APPLICATION NO.	FILING DATE	FIRST NAMED INVENTOR	ATTORNEY DOCKET NO.	CONFIRMATION NO.
10/596,518	08/16/2006	Erwin Hartmann	INA-44	7517
20311 7590 04/27/2009 LUCAS & MERCANTI, LLP 475 PARK AVENUE SOUTH 15TH FLOOR NEW YORK, NY 10016				
EXAMINER				
PATEL, VISHAL A				
ART UNIT		PAPER NUMBER		
3676				
MAIL DATE		DELIVERY MODE		
04/27/2009		PAPER

Office Action Summary

DETAILED ACTION

**Fig.3.***Claim Rejections - 35 USC § 103*

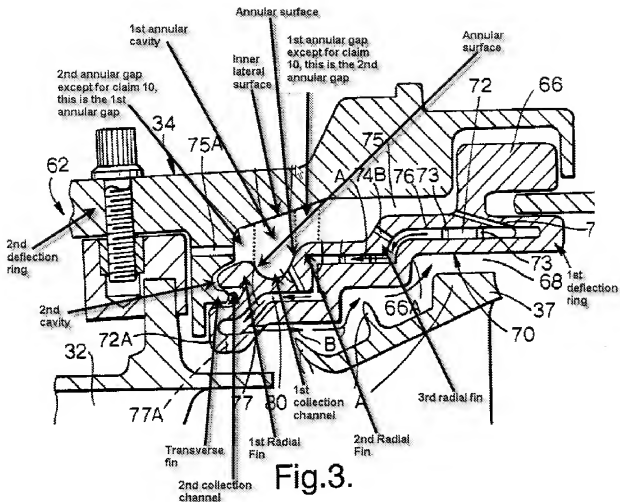
3. Claims 25, 4, 6, 8-11 and 13-14 are rejected under 35 U.S.C. 102(b) as being anticipated by Lawer et al (US. 20040090013A1).

Lawer discloses a seal for an annular opening between members, the seal comprising: a first deflection ring concentrically arranged inside a second deflector ring and about a common axis of rotation; two radial fins formed on the first deflection ring, extending radial outward towards the second deflection ring without contacting the second deflection ring; a smooth, outwardly conical, inner lateral surface formed on the second deflection ring, radially opposing the two radial fins; a first collection channel delimited axially by the two radial fins and radially by the first deflection ring; a first annular cavity delimited axially by the two radial fins and delimited radially by the first collection channel and the inner lateral surface; and a second

collection channel delimited by a transverse fin extending axially from an inward radial limb of the second deflection ring, the inward radial limb axially inward of the first deflection ring, the second collection channel radially inward of the first collection channel and the two radial fins (see figure below).

Regarding claim 3: The first cavity has presents a radially innermost bottom whose radial distance to the second deflector ring is greater than the axial distance between the adjacent radial fins that bound the cavity (figure below).

Regarding claim 4: A first radial fin of the two radial fins is arranged further axially outward than a second of the two radial fins at the seal and at least partially closes off the seal with respect to an environment surrounding the seal in the axial direction is radially longer than the second radial fin (figure below).

Regarding claim 6: The first cavity is bound by annular surfaces that radially increase in distance from one another towards the second deflector ring (figure below).

Regarding claim 7: The annular surface is inclined at an angle with respect to the axis of rotation (figure below).

Regarding claim 8: The first cavity merges axially into a radial first annular gap between a first radial fin of the two radial fins and the second deflector ring and into a radial second annular gap between a second radial fin of the two radial fins and the second deflector ring (figure below).

Regarding claim 9: The first annular gap on an axially outer side of the first radial fin between the first deflector ring and the second deflector ring opens out freely into an environment axially surrounding the seal (figure below).

Regarding claim 10: The first annular gap is radially narrower than the second annular gap.

Regarding claim 11: The second annular gap runs radially closer to the axis of rotation than the first annular gap (figure below).

Regarding claim 13: The second annular gap opens out into a second cavity, the second cavity, which is annular in form, being at least partially enclosed by the first deflector ring and the second deflector ring (figure below).

Regarding claim 14: The second radial fin and a third radial fin, at the first deflector ring, lie freely axially opposite one another, separated from one another by the second cavity (figure below).
